CITY OF LOS ANGELES
INTER-DEPARTMENTAL CORRESPONDENCE

Date: May 7, 2021

Subject: **LAX AIRFIELD & TERMINAL MODERNIZATION PROJECT (ATMP) ACCESS AND CIRCULATION ANALYSIS - LADOT ASSESSMENT AND RECOMMENDATIONS**

Figure 1
LAX Airfield and Terminal Modernization Project
Proposed Project Roadway System

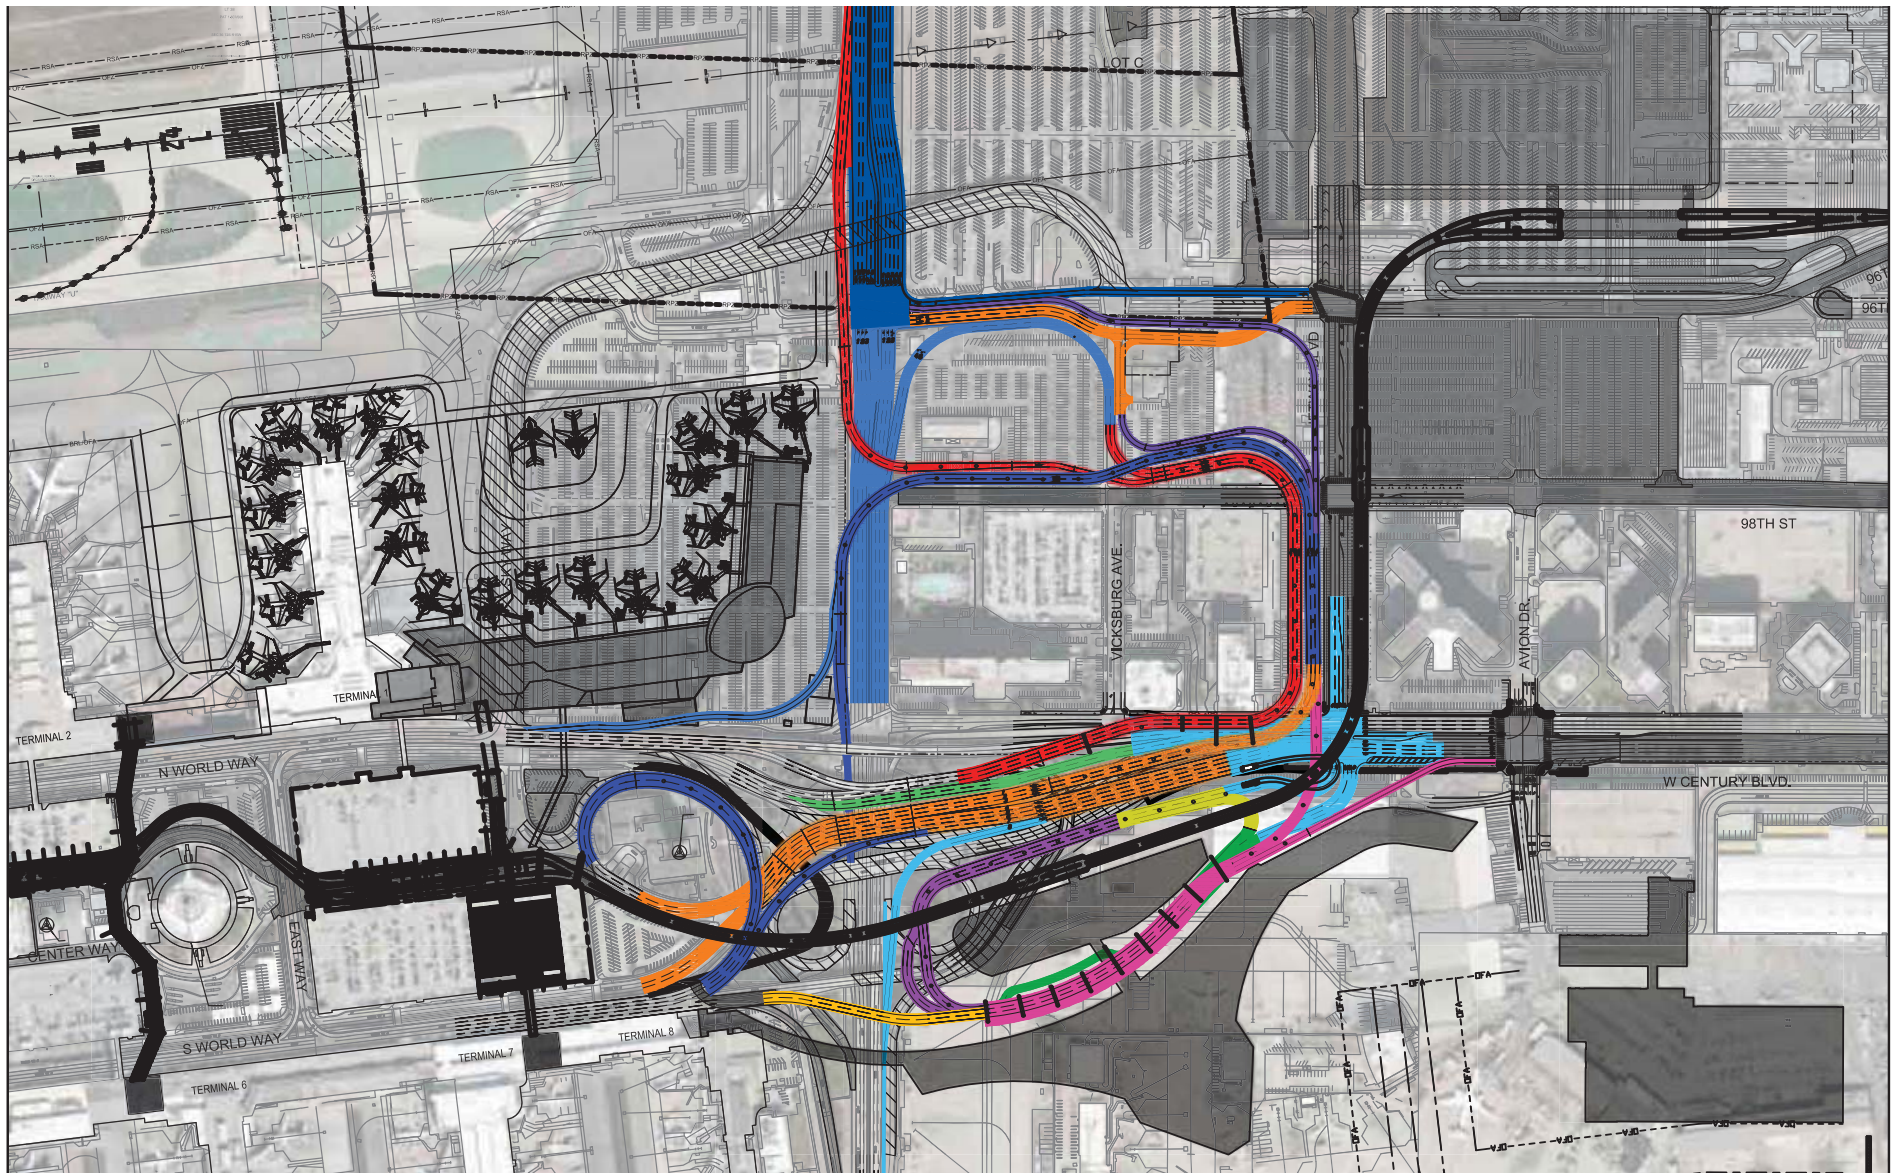
The roadway improvements are comprised of new arrival and departure roadways and a parking facility to support Terminal 9; an additional station on the previously-approved LAX Automated People Mover (APM) line with a pedestrian connection to Terminal 9; a pedestrian corridor between Terminals 8 and 9 that would bridge Sepulveda Boulevard; and new roadway segments to improve vehicle access into and out of the LAX CTA.

The Project identified this location for corrective action to address an anticipated deficient condition. Project-related queuing deficiencies were identified at this intersection for the westbound right movement on 96th Street and the northbound through movement on Sepulveda Boulevard. In addition to this forecasted queuing, there are a number of key operational considerations that LAWA should explore with LADOT staff, including specific demands by intersection movement and pedestrian access and safety. Specific attention to the pedestrian access issue also extends to the new northbound right turn slip lane being proposed by the project that will serve as the new entry point to the CTA from northbound Sepulveda Boulevard. Please engage LADOT staff early in the pre-design process to consider design options and operational needs for this location.

Just as with the 96th Street & Sepulveda Boulevard intersection, there are a number of design details that should be worked out early to properly complete the configuration of this segment. For example, this roadway segment will include critical curve radius and sight distance requirements that will have to meet the Bureau of Engineering (BOE) Roadway Design standards.

- II. Northbound Slip Lane to Eastbound 96th Street: There is a slip lane proposed as part of the new CTA access roadway system that could pose a significant challenge for pedestrian movement along the east side of Sepulveda Boulevard. Therefore, careful consideration of this issue should be provided when completing the design details for this element of the new CTA access roadway system. Final designs should consider some form of high visibility traffic control to ensure safe and protected pedestrian crossings.

This stretch of roadway is one of the primary corridors of the new CTA access roadway system. LAWA should work with LADOT to consider design options that do not result in a substandard active transportation environment. Pedestrian access remains a priority consideration when finalizing the design work for this corridor to ensure that sidewalks and parkways are properly considered.

The report also discusses the removal of bike lanes through this corridor. Please note that Section 4.15 of the Mobility Element of the General Plan (i.e., Mobility Plan 2035) requires a public hearing for the proposed removal of an existing Class II or Class IV bicycle facility.

The Project will significantly reconfigure this intersection to accommodate the new CTA access roadway system. When designing the reconfiguration, safe pedestrian crossings should be provided to ensure protected pedestrian access in and around the CTA.

Pedestrian access along the south side of Century Boulevard currently terminates at Avion Drive. In order to provide complete access to the new Terminal 9 facility, the Project should include an extension of this access to the new Jetway intersection.
